**FINAL DRAINAGE REPORT
FOR
HOMESTEAD NORTH AT STERLING RANCH FILING NO. 3**

**August 2022
Project No. 25188.12**

SF-22-XX

SF2229

Swale A-A

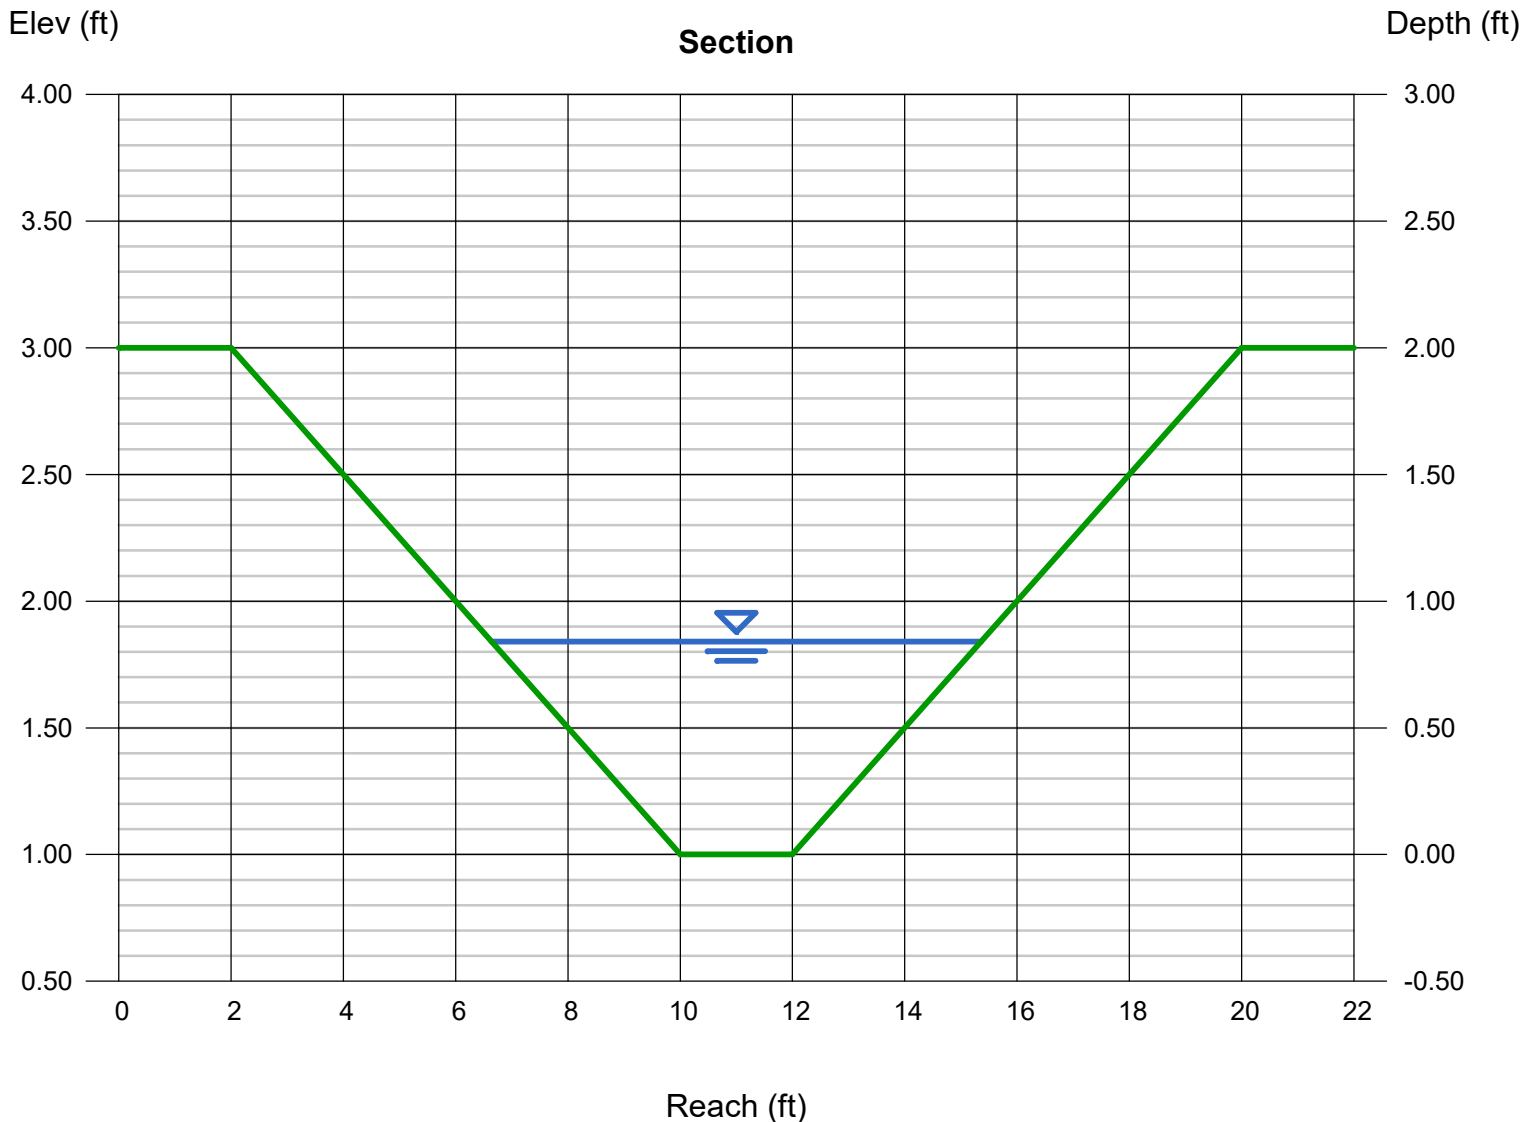
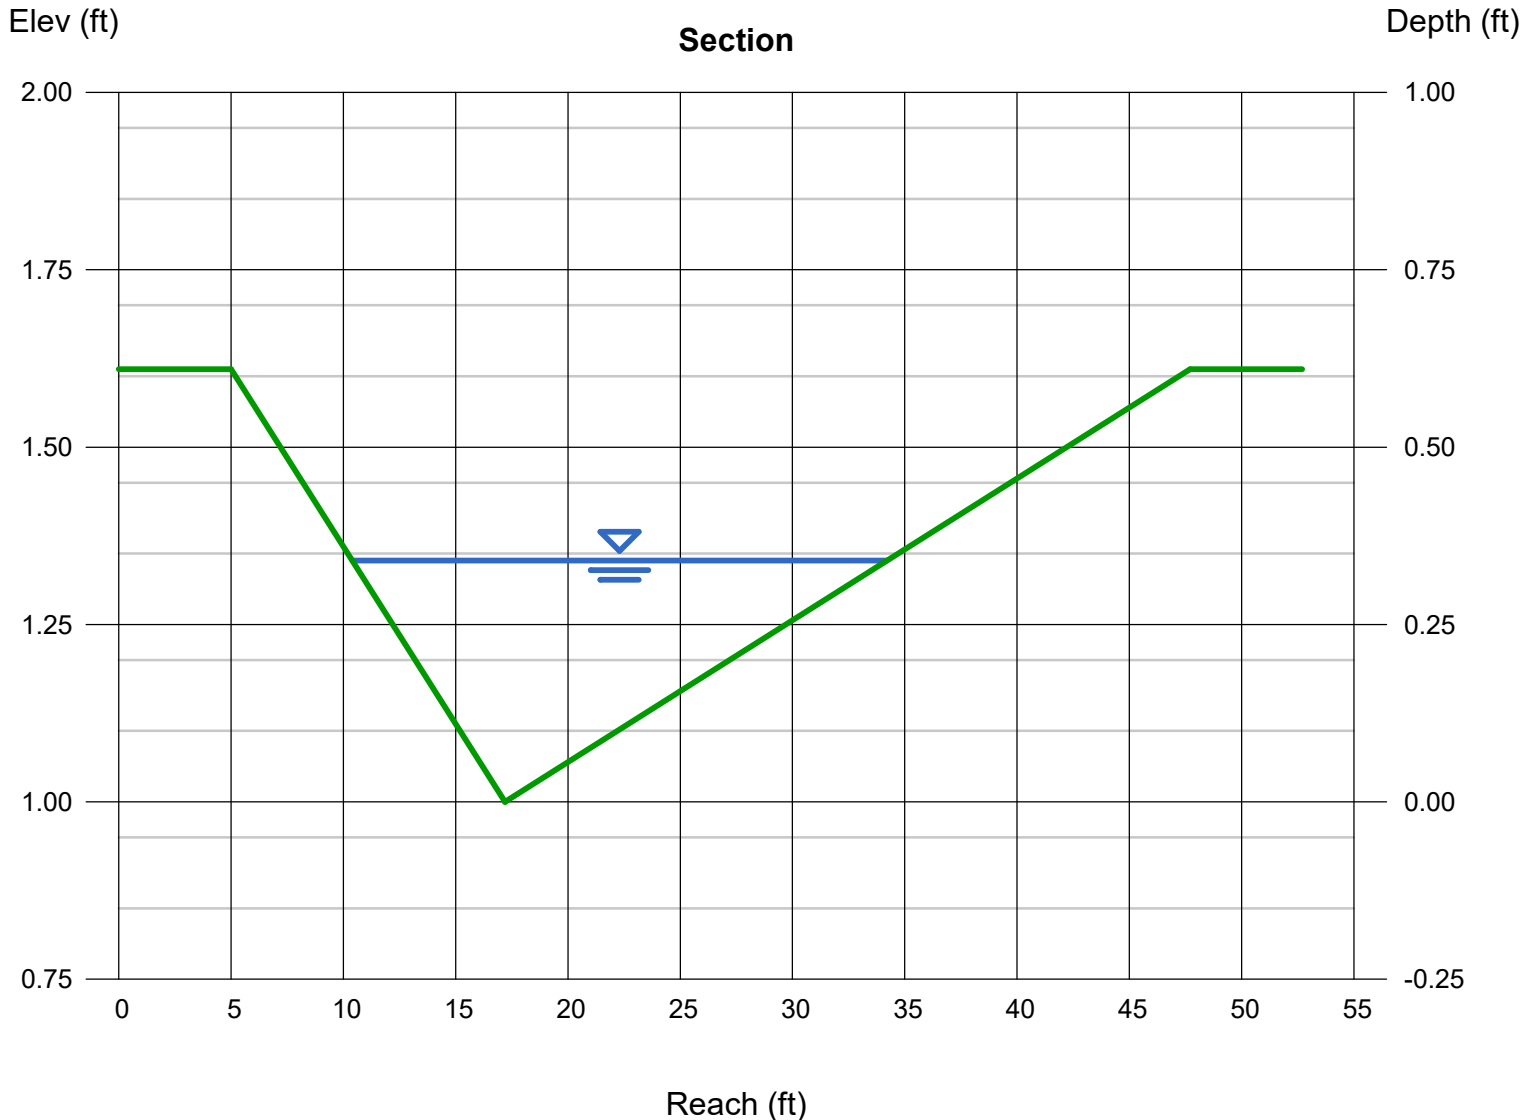
This sheet appears to be a duplicate. Please delete.

JR Response: Removed

DETENTION BASIN OUTLET STRUCTURE DESIGN

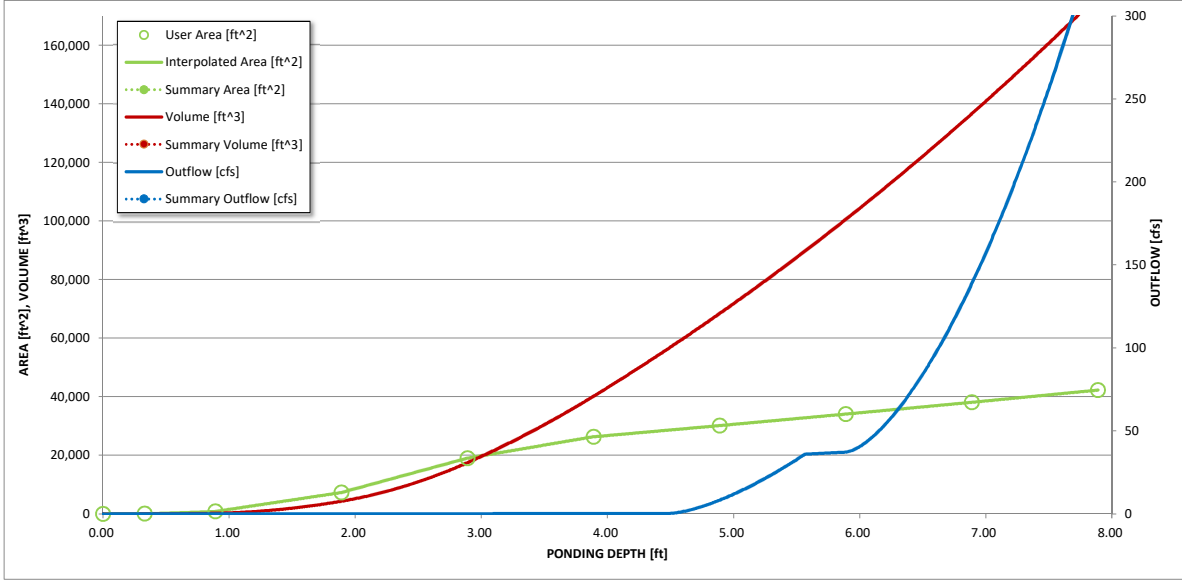
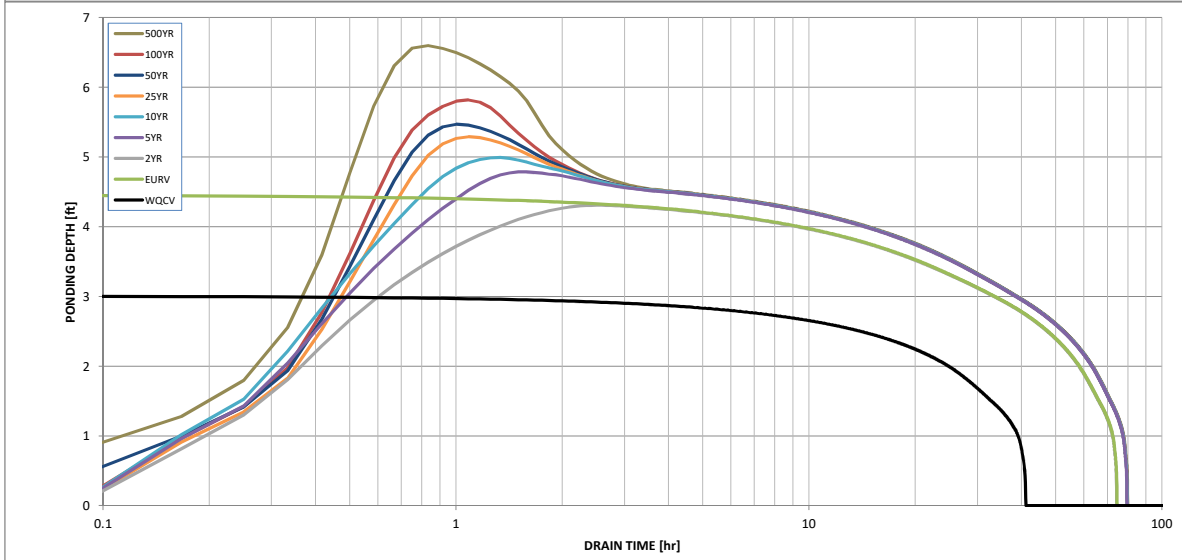
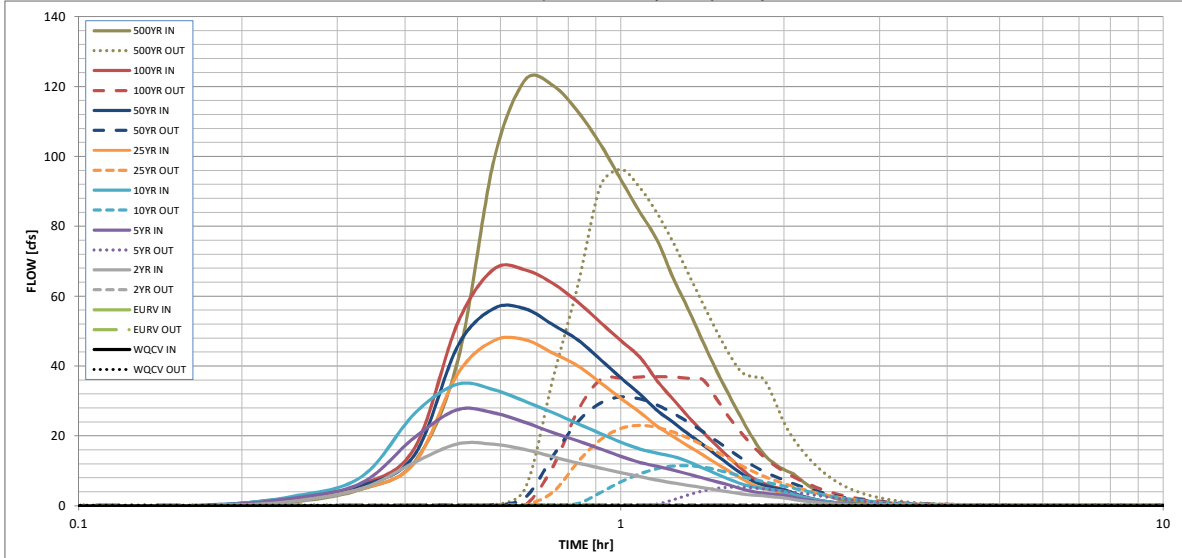
Not providing enough stored volume for 100-year storm

JR Response: The maximum ponding depth is below the spillway indicating the 100-year storm is detained within the pond.

PROPOSED CONDITIONS DRAINAGE MAP
HOMESTEAD NORTH AT STERLING RANCH FILING NO. 3
JOB NO. 25188.10
08-02-2022
SHEET 1 OF 1

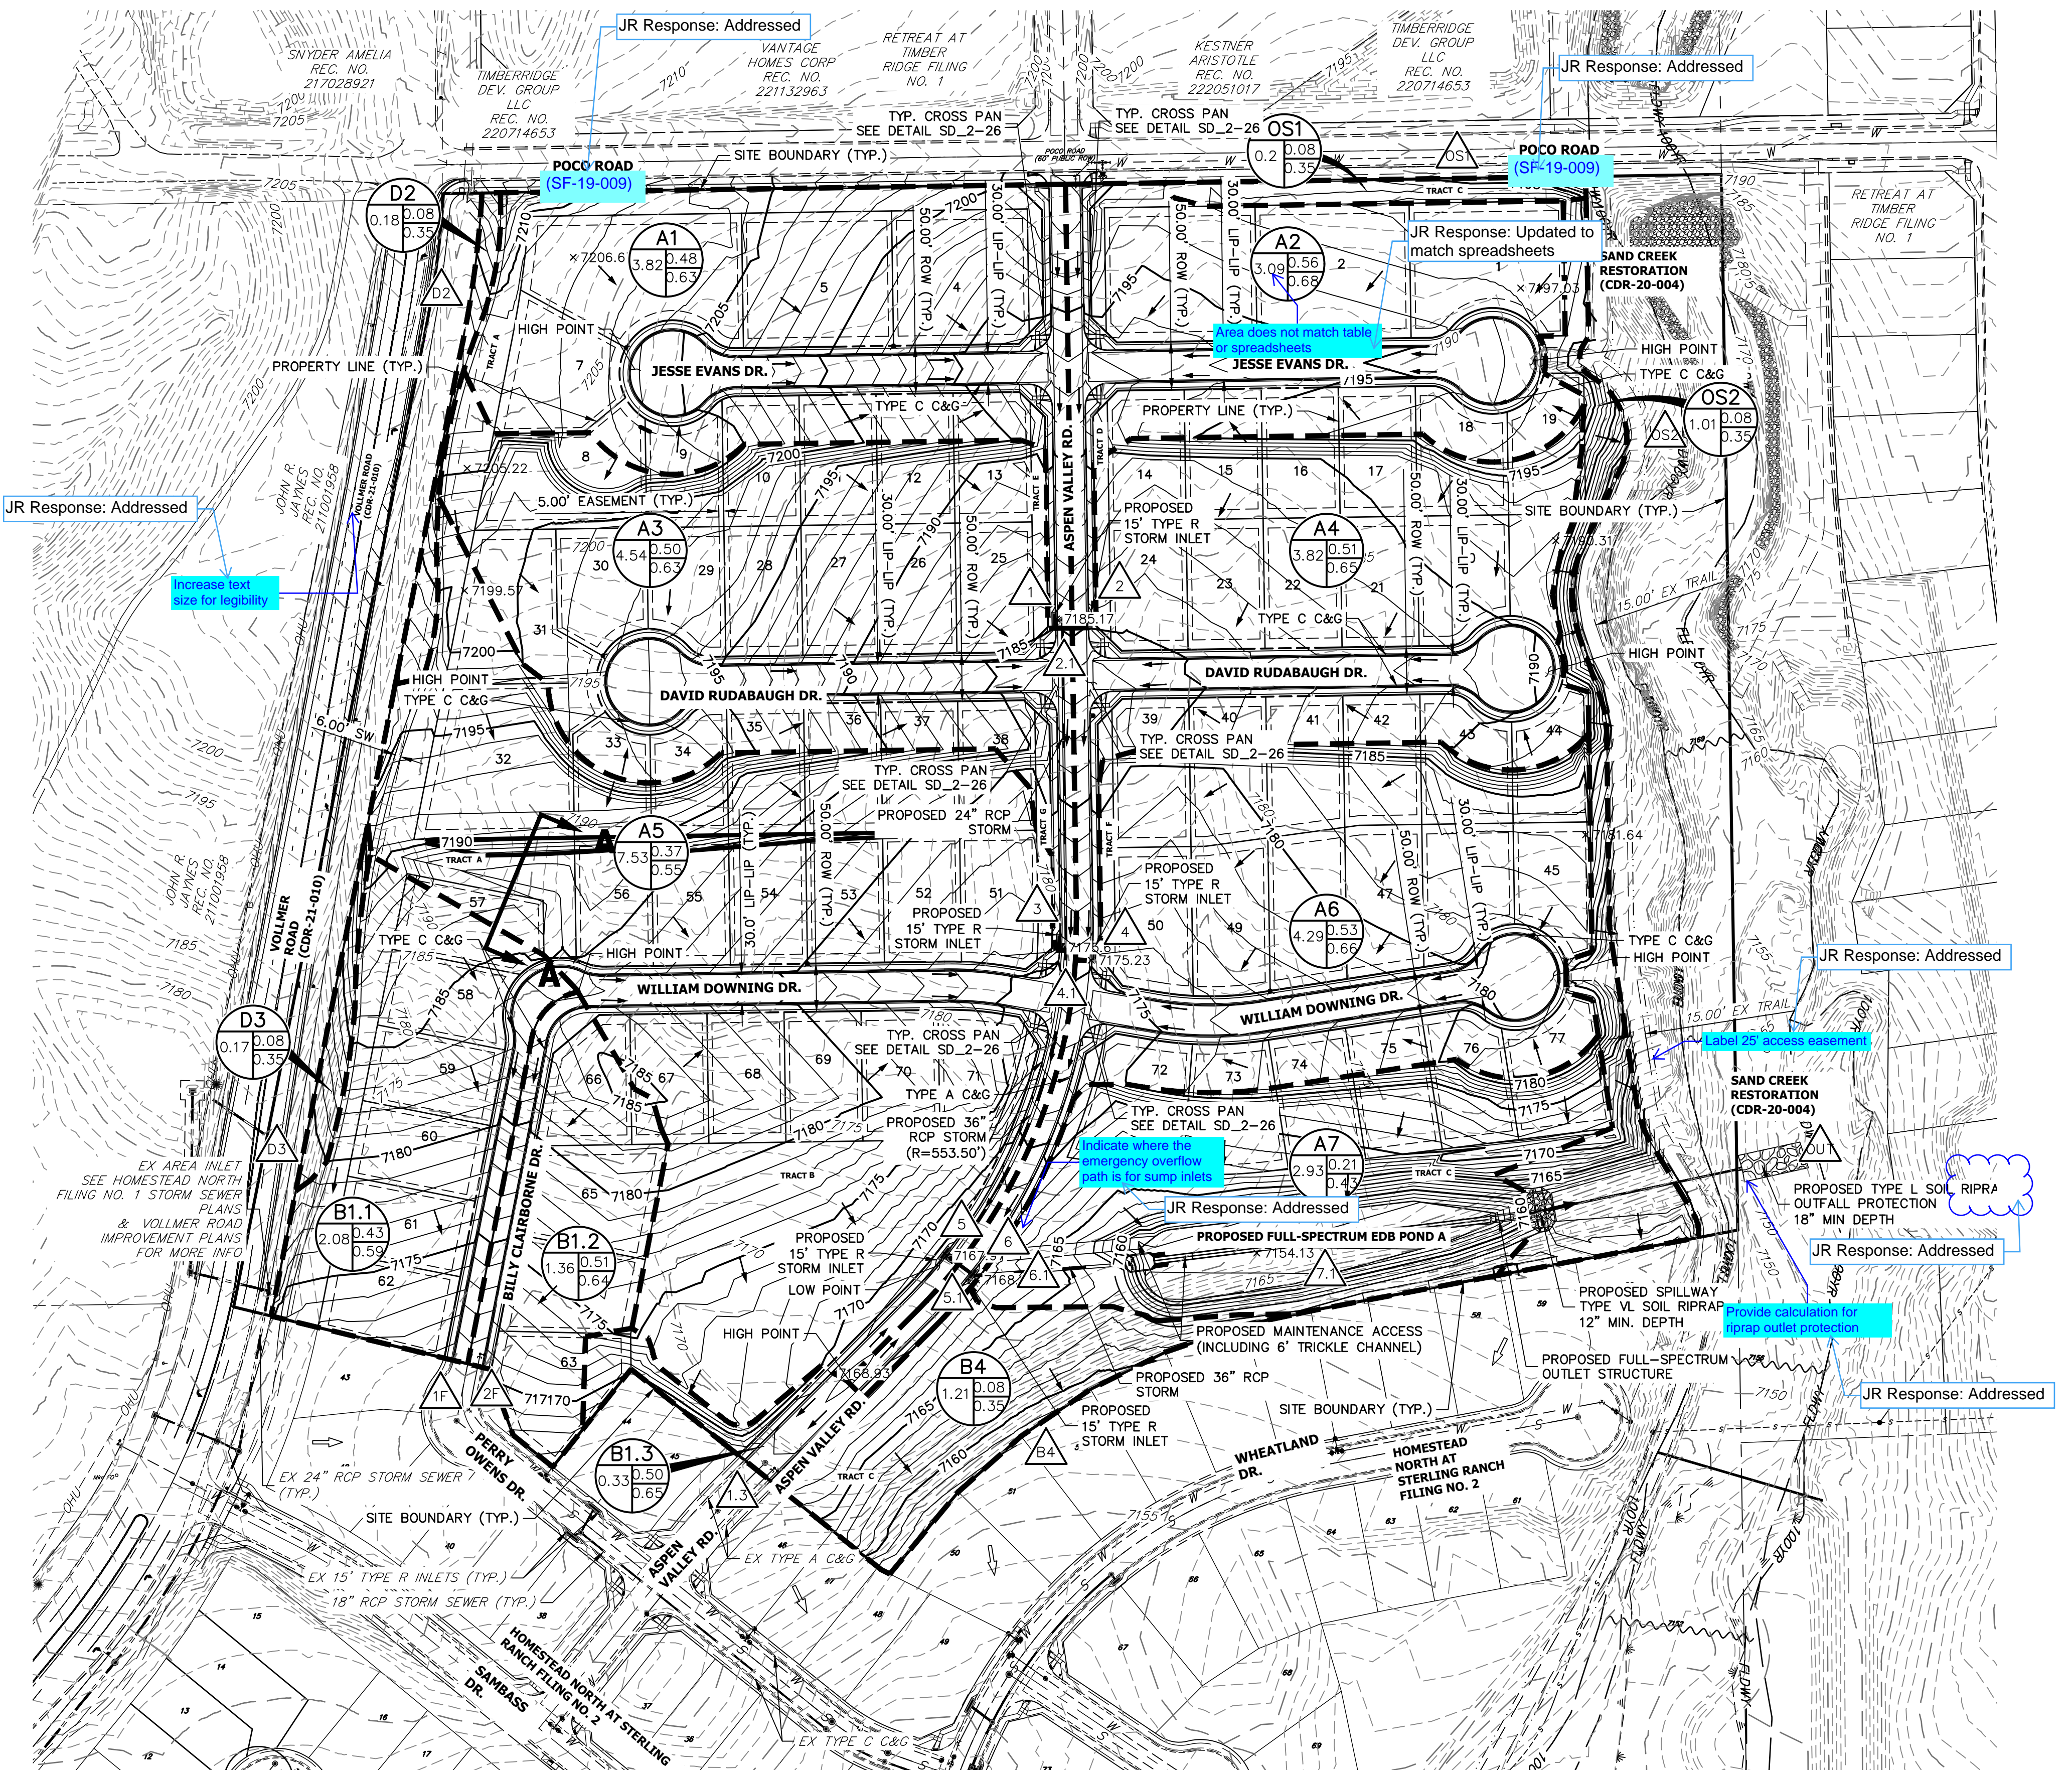
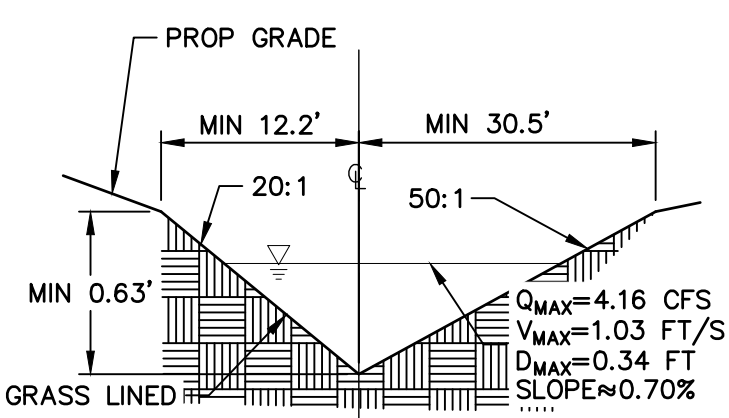
Add proposed items to legend

JR Response: Addressed
